Statement of Work

Procedure to rework 151X1225DF01PC02 due to false De-sat

This doc is to guide “Louisville Service Center” to rework 20Nm pitch power converter for solving false de-sat issue.

151X1225DF01PC02 or 104W4708P002

3.3 Remove coating of Capacitors (**C34, C35, C44, C60**)

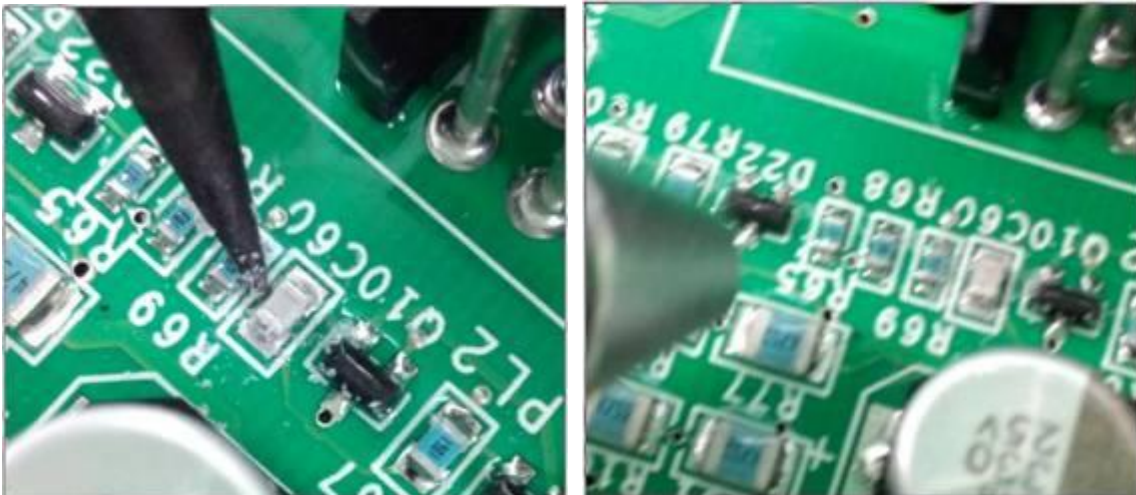
3.2 Locate Capacitors (**C34, C35, C44, C60**)

Use ESD bar to scrape the conformal coating.
Clean by ESD ionizer.
Use Industrial alcohol to clean the board area.
Clean by using DI Water.

3.4 Remove Capacitors (**C34, C35, C44, C60**)

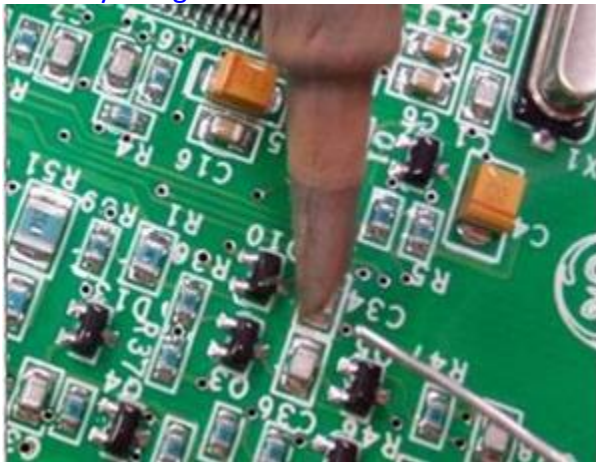
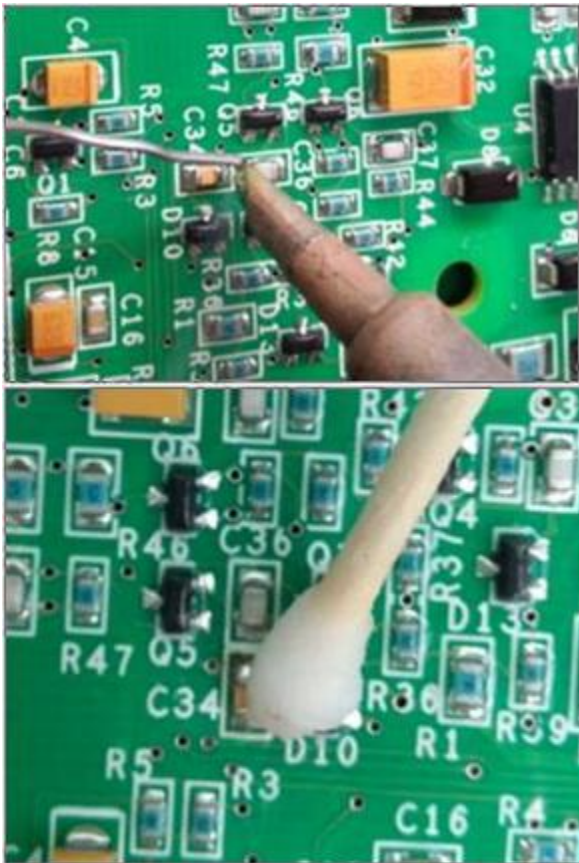
Remove capacitors by solder iron.

3.4 Install new Capacitors (**C34, C35, C44, C60**)

After capacitors installed, clean and dry (C34, C35, C44, C60) pads.

3.5 Conformal Coating Capacitors (**C34, C35, C44, C60**)

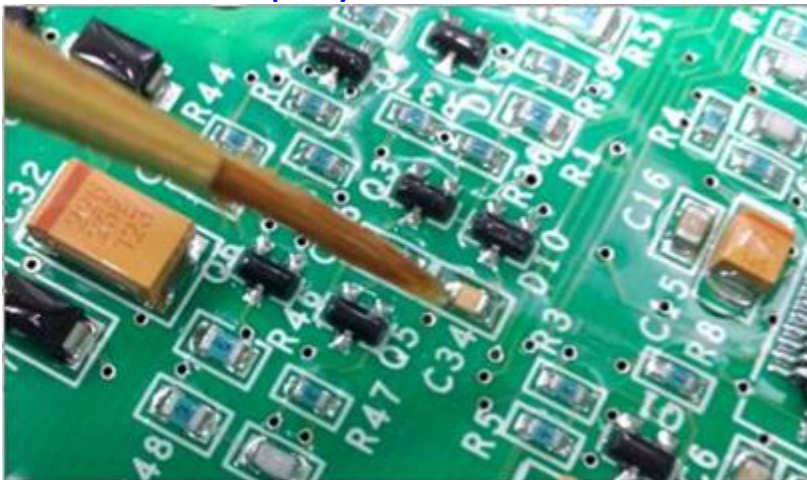
Use brush to coating the oil at the specifically area.

Use heat gun to heat up for coat frozen.

Note: **Do not seal impurity in.**

3.6.1 circuit board label after rework

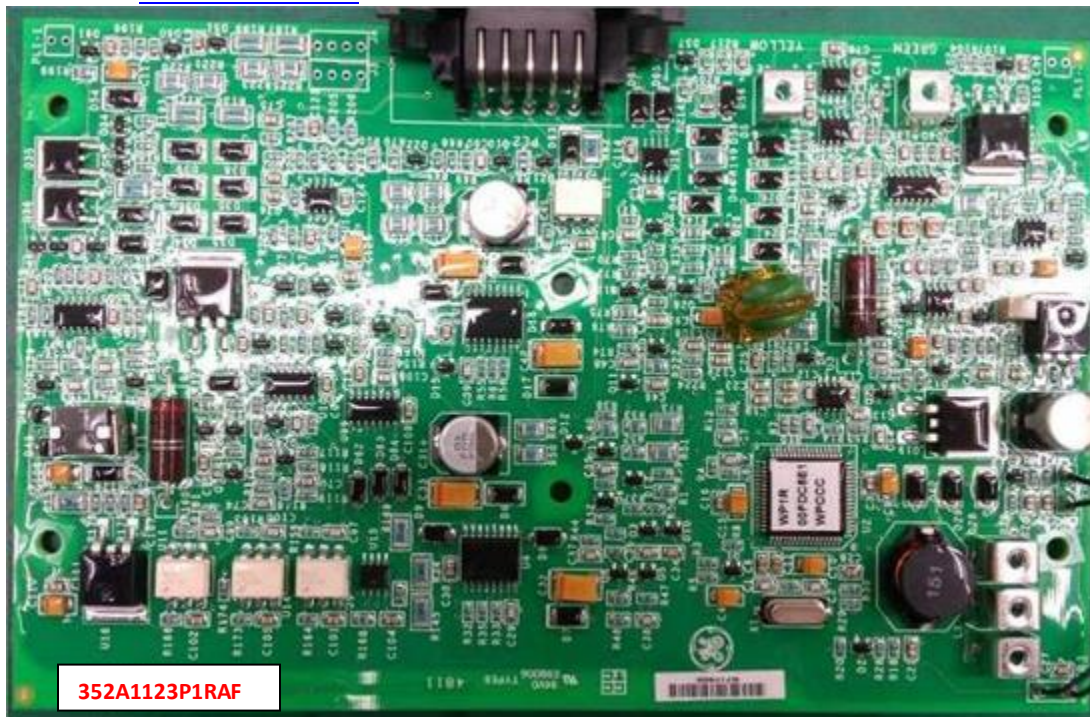
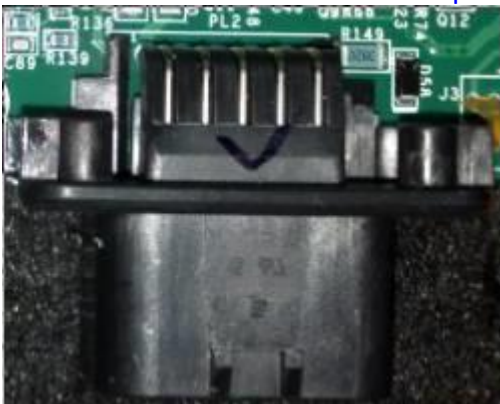
Put label "**352A1123P1RAF**" to reworked WPCCC card.

Mark reworked board with "V" on part PL2.

a. if the 151X1225DF01PC02R0 had been energized and used for any commercial operation in the field, it is considered a service unit.

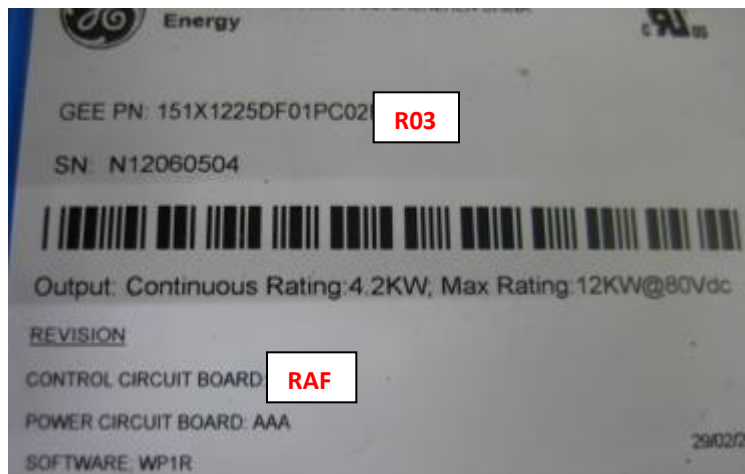
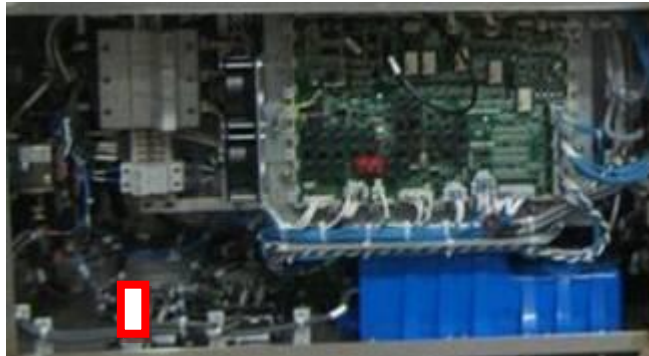
- Change module label PN marking from 151X1225DF01PC02R0 to 151X1225DF01PC02R03.
- Add label RAF on top of RAE on label area “control circuit board”
 - Add module label PN marking 104W4708R003 on the side cover.
 - Label the shipping box with 104W4708R003

- Add module label PN marking 104W4708R003 on the side cover.

b. if the 151X1225DF01PC02R0 has not been used for any commercial operation in the field, it is considered a factory unit.

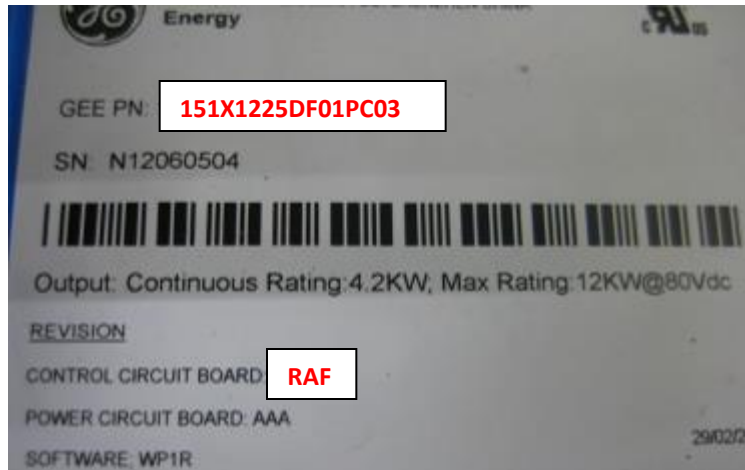
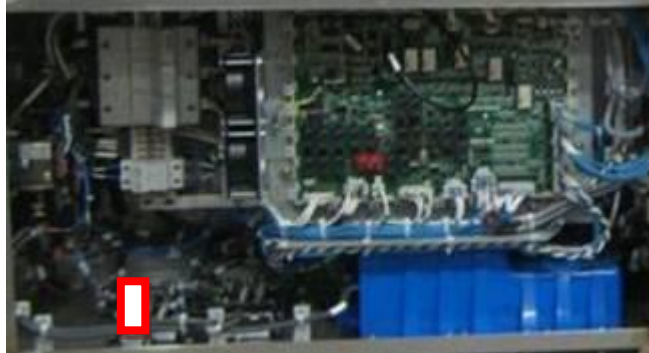
- Change module label PN marking from 151X1225DF01PC02R0 to 151X1225DF01PC03
- Add label RAF on top of RAE on label area “control circuit board”

- Add module label PN marking 104W4708R003 on the side cover.

Schematic

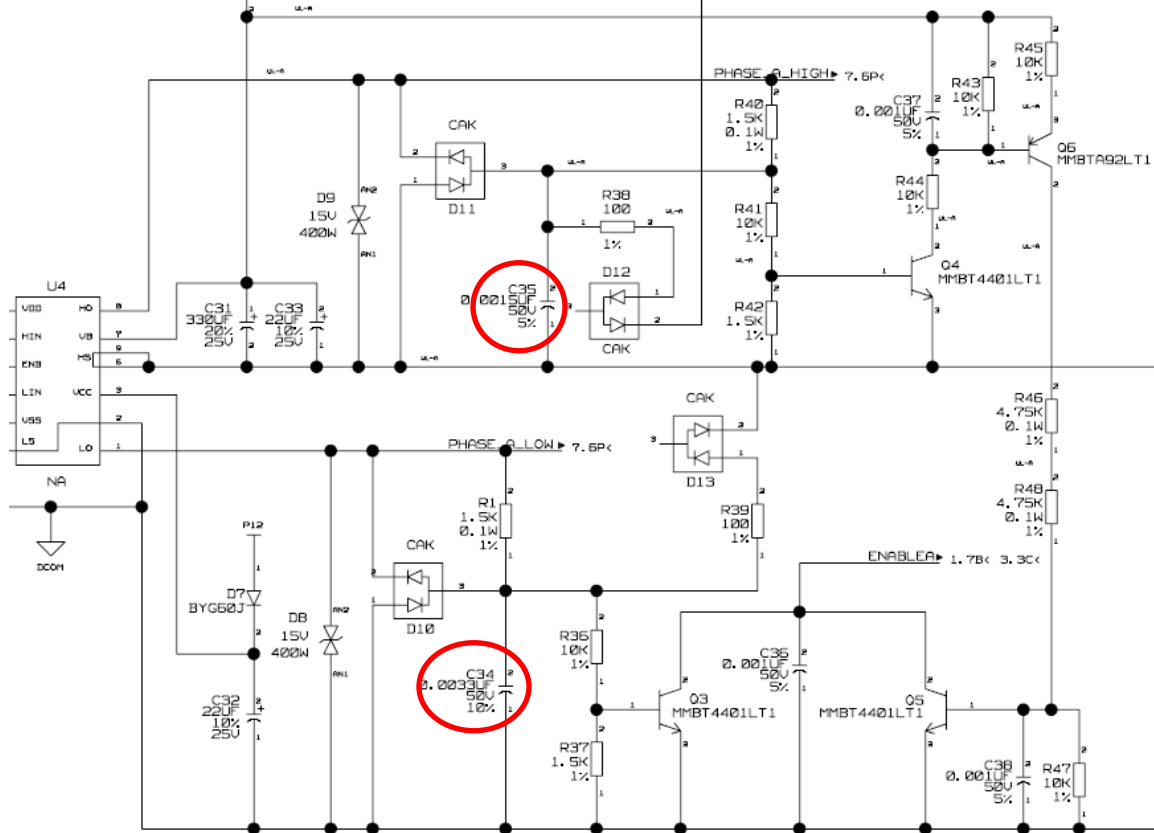
This method (replacing C34, C35, C44, C60 with 0.0047uF caps) need to be verified at wind sites, before formal release.

C34, C35 in Bridge/Phase A De-sat detection circuitry

C44, C60 in Bridge/Phase B De-sat detection circuitry
